Re: Protested Applications in the name of Timothy P. Deeg, referred to as Transfer
No. 71132, and Amendment of Permits Nos. 41-7076 and 41-7081,

MEMORANDUM

SUBJECT: RE-CALULATION OF ACRES WATER RIGHTS 41-7076 & 41-7081

REVIEW OF ACRES - ATTACHMENT A

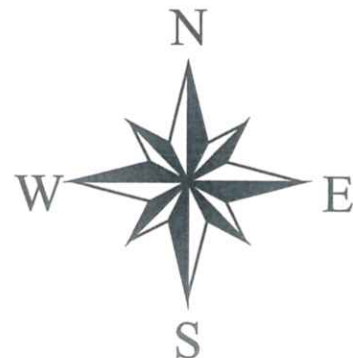
In my review of the acres for water right 41-7076, I agree that some of the acres were not accounted for in my original exam. My original exam didn't take into account the end gun use on the pivot when calculating the acres. I based my original acre calculations on the acres I planimetered and those that were listed on the FSA aerial photo at the time of the exam. The new ArcView technology has allowed us to do a better job of calculating acres, so I was not surprised that Brockway found a difference in the acres using the latest technology. The difficulty was that we needed to find a 1997 aerial photo that was taken at the time proof of beneficial use was filed. Brockway supplied this aerial photo.

Please see Attachment A for the ArcView shapes that I created using the 1997 aerial photo. My new shape file revealed that there were 239 acres actually irrigated instead of the 227.5 originally recommended. Brockway found 240.5 acres, but the difference between Brockway and my calculations were generally due to rounding, and line placement. Please see attachment C for a comparison of the acres.

This is a map of the re-calculated acres associated with permit 41-7076. My original field exam was done without the benefit of using ArcView, so this method of acre determination is more accurate. This is a 1997 aerial photo supplied by Brockway Engineering. The 1997 photo shows that an end gun was used in the corners of pivots, which skewed my earlier calculations slightly for each 40 acre tract. The total acres for this permit should be 239 acres or 11.5 acres more than what was originally recommended in my field exam. The diversion rate and volume recommended were based on the capacity of the pivot, and not the acres, so those recommendations should remain.

I RECOMMEND THAT FIELD EXAM RECOMMENDATION BE CORRECTED TO SHOW THE ADJUSTED ACRES IN ATTACHMENT C. THE DIVERSION RATE AND VOLUME WERE NOT BASED ON THE ACRE AMOUNT, SO THOSE AMOUNTS SHOULD NOT BE CHANGED FROM MY ORIGINAL RECOMMENDATION.

REVIEW OF ACRES - ATTACHMENT B

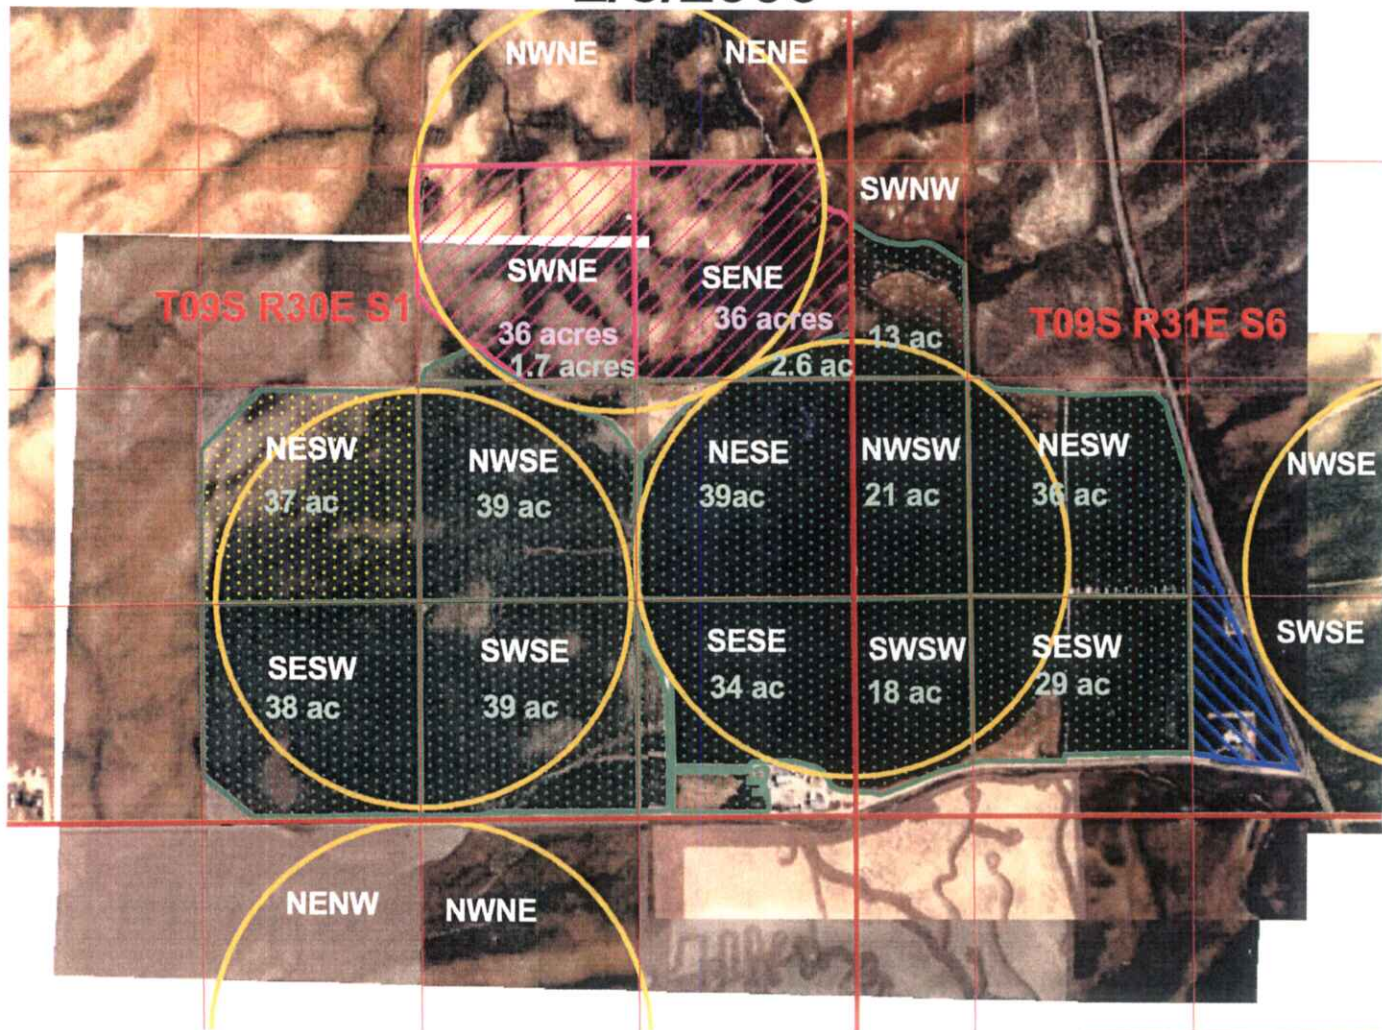
In my review of the acres for water right 41-7081, I agree that some of the acres were not accounted for in my original exam. My original exam didn't take into account the end gun use and the swing arm use on the West Pivot when calculating the acres. I based my original acre calculations on the acres I planimetered and those that were listed on the FSA aerial photo at the time of the exam. The new ArcView technology has allowed us to do a better job of calculating acres, so I was not surprised that Brockway found a difference in the acres using the latest technology. The difficulty was that we needed to find a 1994 aerial photo that was taken at the time proof of beneficial use was filed. Brockway supplied this aerial photo.

Please see Attachment B for the ArcView shapes that I created using the 1994 aerial photo. My new shape file revealed that there were 347.3 acres actually irrigated instead of the 338 originally recommended. Brockway found 358.5 acres, but the difference between Brockway and my calculations were generally due to rounding, and line placement except for the lands in the SE and NE of Section 1. The permit also limits the total acres allowed to 348 acres, so my new calculations will give Mr. Deeg very close to the maximum amount allowable under 41-7081.

Brockway did not take into account overlapping water rights when creating his shape files, so there are a couple of discrepancies. There is approximately 9.4 acre in the SE S6 that are covered under water right 41-7071. Mr. Brockway included these acres in his total acre calculations when they were covered by another right.

Water right 41-7030 was transferred to NE ¼ S1 in 1994, and even though the transfer took place after the proof of beneficial use was filed for this permit, the aerial photo does suggest that the pivot was installed at the time the aerial photo was taken. If the pivot was in place at the time of the aerial photo, it is difficult to determine which acres should be allocated to 41-7030 and 41-7081. However, by filing the transfer on water right 41-7030 for 36 acres in SWNE and 36 acres in the SENE of S1 it does suggest that the acres from 41-7030 were needed to bring the total acres licensed up to the total acres irrigated in 1994 for these two 40-acre tracts.

The above maps show the re-calculated place of use for water right 41-7081. The aerial photo is a 1994 aerial photo supplied by Brockway Engineering. Brockway Engineering determined that some acres hadn't been accounted for in the original field exam. This is true in some cases, but Brockway Engineering neglected to take into account the other rights on the property. Brockway included lands irrigated by 41-7071 in the NWSE and SWSE of Section 6. They also included lands irrigated in the SENE S1 under water right 41-7030. Water right 41-7071 existed before this permit and 41-7030 was transferred to this property at approximately the same time, so the acres for both these rights needed to be removed before acres could be allocated to this permit. I have increased the total number of acres by approximately 9.4 cres. These acres are mainly found in the NESW and SESW of S1. The remaining 40 acre tracts were increased mainly due to new rounding protocol.

I RECOMMEND THAT FIELD EXAM RECOMMENDATION BE CORRECTED TO SHOW THE ADJUSTED ACRES IN ATTACHMENT D. THE DIVERSION RATE WAS BASED ON A SYSTEM CAPACITY, SO IT SHOULD NOT CHANGE. THE VOLUME WAS BASED ON THE ACRE AMOUNT, SO THE VOLUME SHOULD BE CHANGED TO 1389.2 AFA.
